1610 Clinch Ave. 37916

Staff Report

File Number: 6-E-24-HZ

Proposed reconstruction of roofline and addition of dormers, along with an exterior rehabilitation.

Title: SITE PLAN

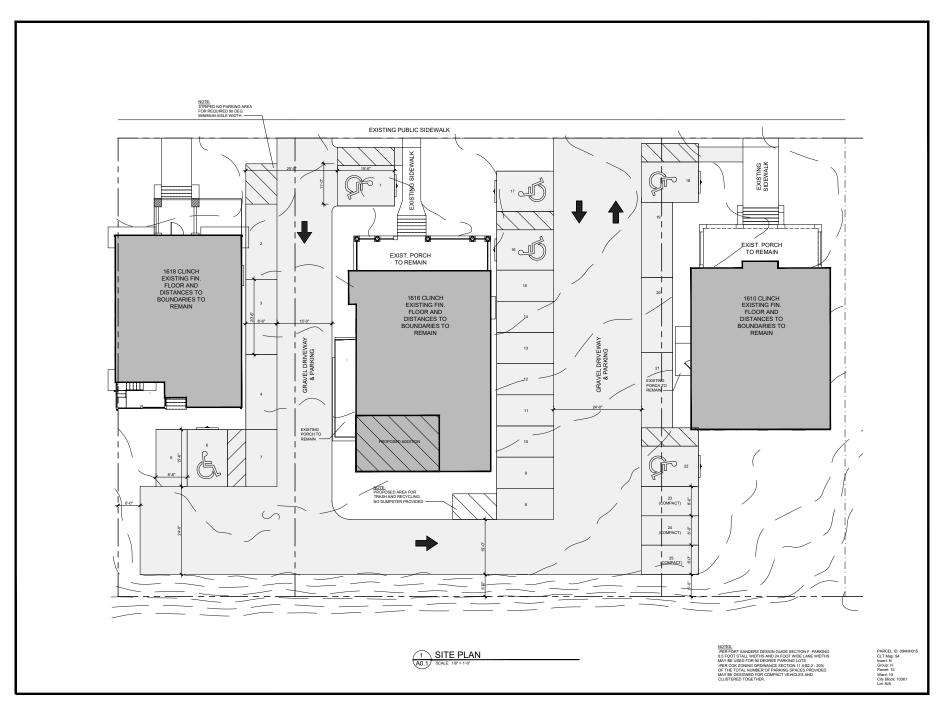
- 5. Guidelines for parking recommend providing parking access off the alley or a side street, and note that "surface parking area shall always be to the rear of the building." Access from the alley does not appear feasible due to the substantial slope at the rear of the property, the narrow width of the alley, and the placement of the parking garage to the rear. 1610 and 1616 Clinch Avenue already have large gravel surface parking lots between the two houses, and front driveways extend off Clinch Avenue up to 1630 Clinch Avenue. All efforts should be taken to place new parking areas beside or behind the primary building, and avoid the front yard. Final site plan revisions will be necessary based on accessible parking requirements and City Engineering standards. Staff may approve minor revisions to site plans provided they meet the guidelines.

Pending additional discussion by the Historic Zoning Commission on the proposed new roof height and pitch, staff recommends approval of Certificate 6-E-24-HZ, subject to the following conditions: 1) all masonry repair and repointing follow NPS specifications; 2) ground-level windows on the façade elevation should be revised to be double-hung windows, with all other final window installations to reflect elevation drawings submitted for HZC review; 3) final site plan to meet City Engineering standards.

1 FRONT ELEVATION
SCALE: 1/4" = 1'-0"

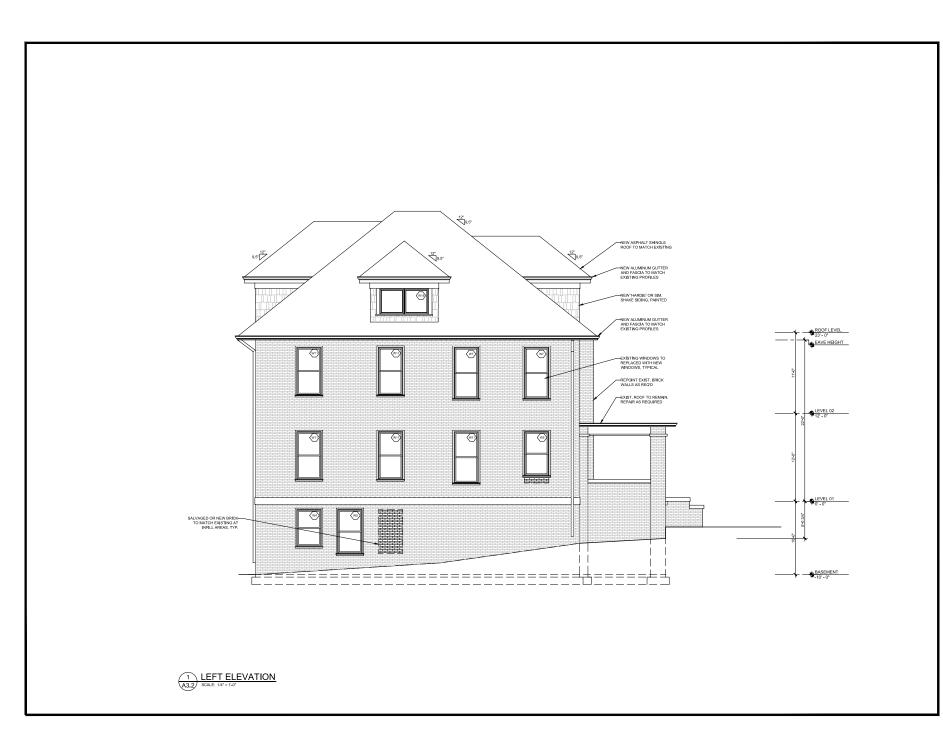
- 1. 1610 Clinch Avenue is a contributing structure to the Fort Sanders National Register Historic District and Neighborhood Conservation Overlay.
- 2. The primary scope of work aims to increase the height and interior capacity of the house's upper level. The addition will increase the building's height by 3' and change the existing roof pitch from 6.5/12 to 9.5/12.

While guidelines recommend that new roof pitches are "not less than an 8/12 pitch," they also recommend that houses remain proportional to comparable houses in height and width. The proposed 9.5/12 pitch roof is comparable to the adjacent houses (1616 Clinch Avenue and 1620 Clinch Avenue) but three feet taller than the original roofline. The Commission should discuss the height and pitch of the new roof.

- 3. The existing building's exterior has already received significant modifications, including replacement windows, new windows in non-original locations, and the enclosure of a rear corner porch. Overall, the proposed window replacements are appropriate within the guidelines, except for the ground-level windows on the façade, which are proposed to be replaced with single-light picture windows. Guidelines state "windows should be double-hung sash windows." New windows should be installed in the originally-sized brick fenestrations (as reflected on the drawings) and avoid further enclosure with trim or siding. The proposed windows to be enclosed are on secondary elevations and at basement level, and are not character-defining features of the building. The elevation drawing retains the door's transom and sidelights, which are character-defining features.
